Product Service Group CE Audio

Service Information

CORRECTIONS TO THE SERVICE MANUAL

READ/WRITE BOARD, VALID FOR PRODUCTION STAGE "5"

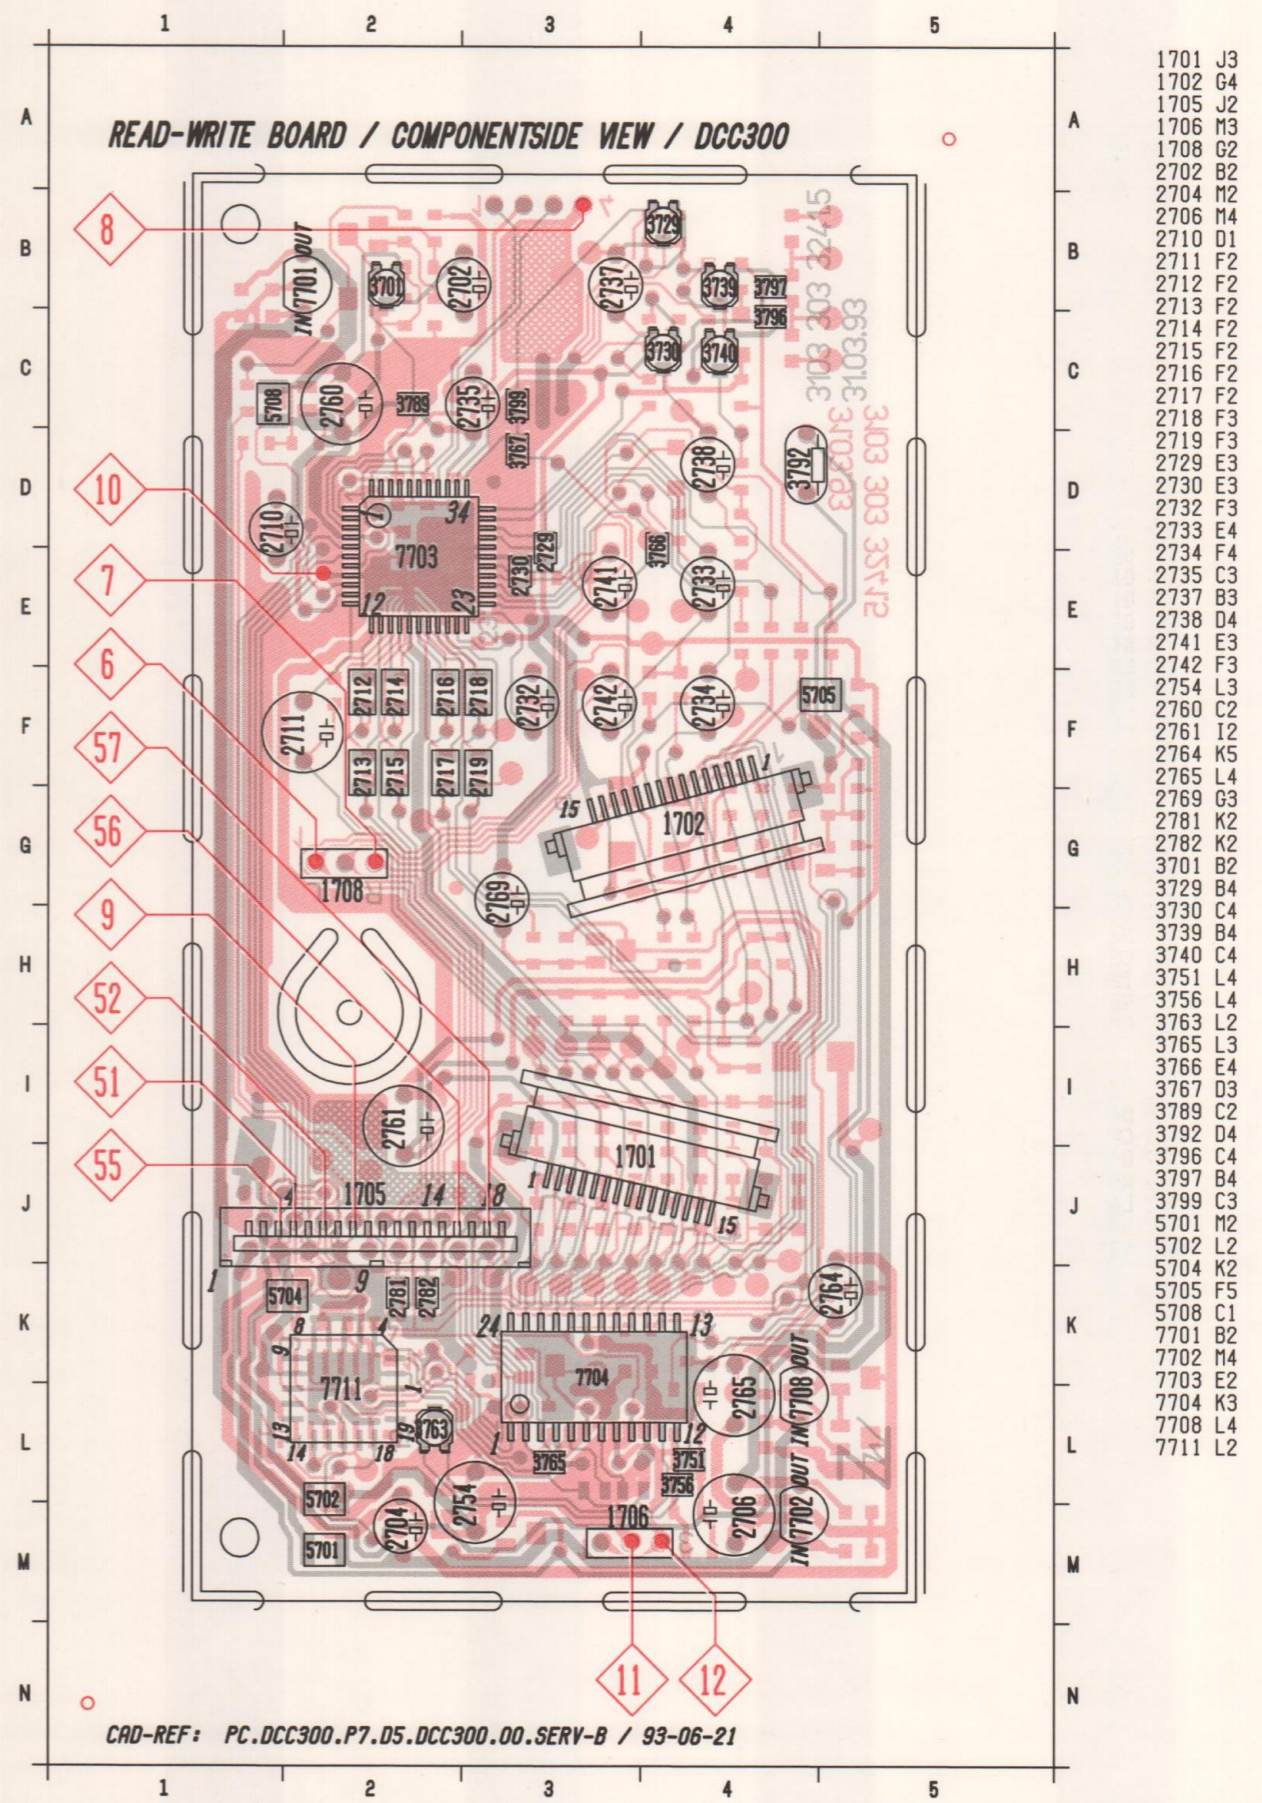
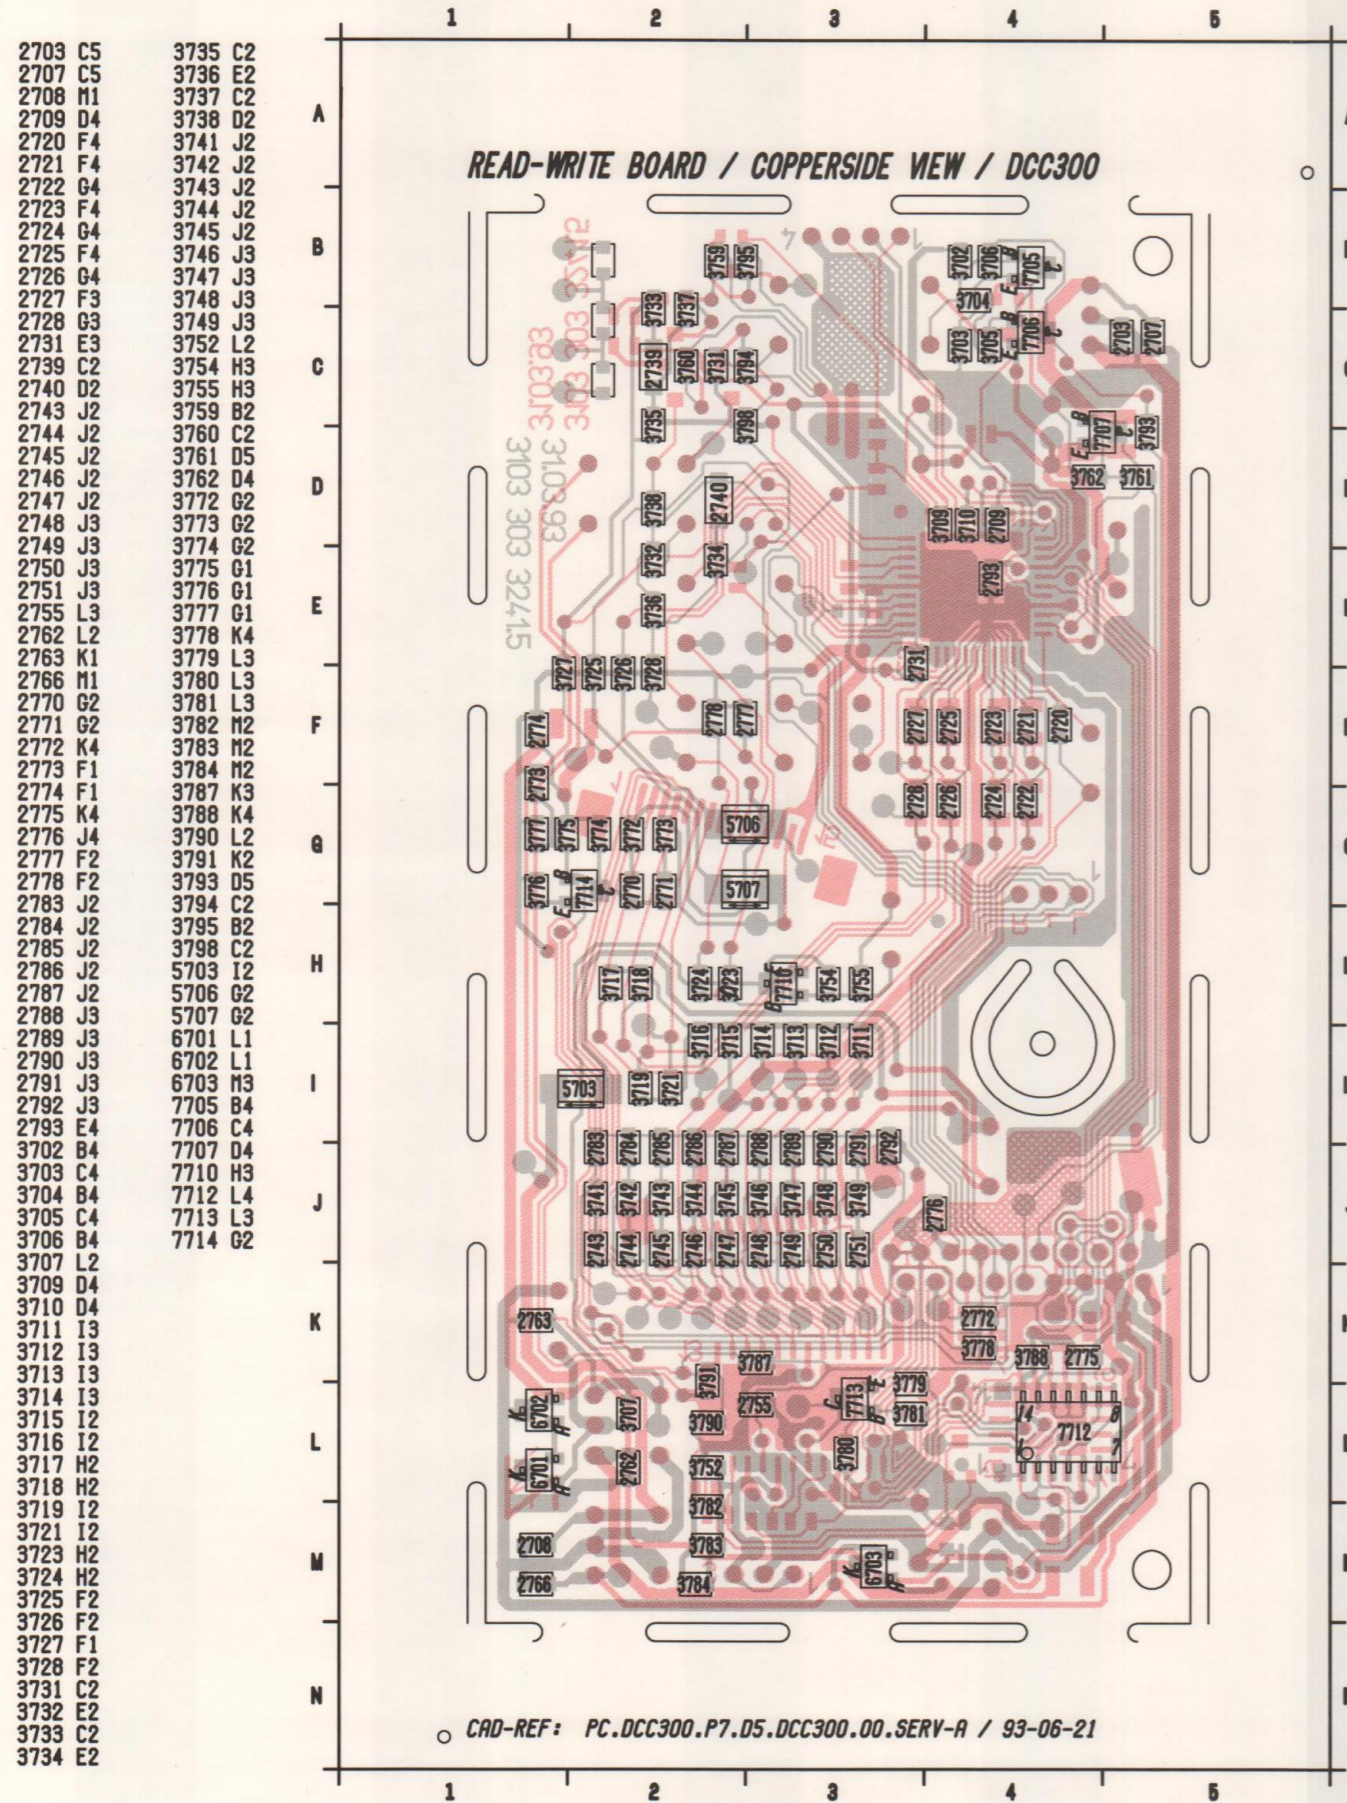
CHANGES IN COURSE OF PRODUCTION**1. Read/Write Board PCB7 (page 50-54)**

Component layout changed into production stage "5". See annex pages marked 54.1 and 54.2. Component layout as published on page 53 and 54 of the service manual is valid for production stages "3" and "4".

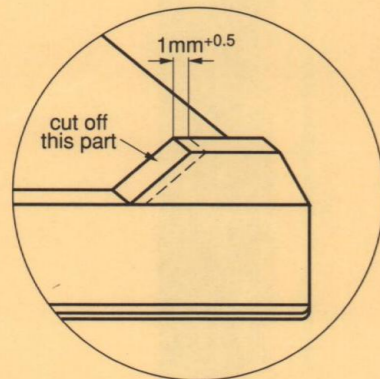
SYMPTOM : When the cassette is lifted at the left side, in order to remove it from the opened tray, the cassette gets stuck behind the front.

CAUSE : The drawer (pos. 209) does not open far enough, because the tray-out switch (pos. 1437) is actuated too early.

CURE : The switch is opened/closed by a ridge, located at the back righthand corner of the drawer. To delay the switch actuation cut off some plastic of the ridge according to the sketch below.

REMARK : This modification also takes an influence on the feature "touch to close". If too much plastic is removed the tray might already close while a cassette is inserted ! Try to find an optimal compromise.
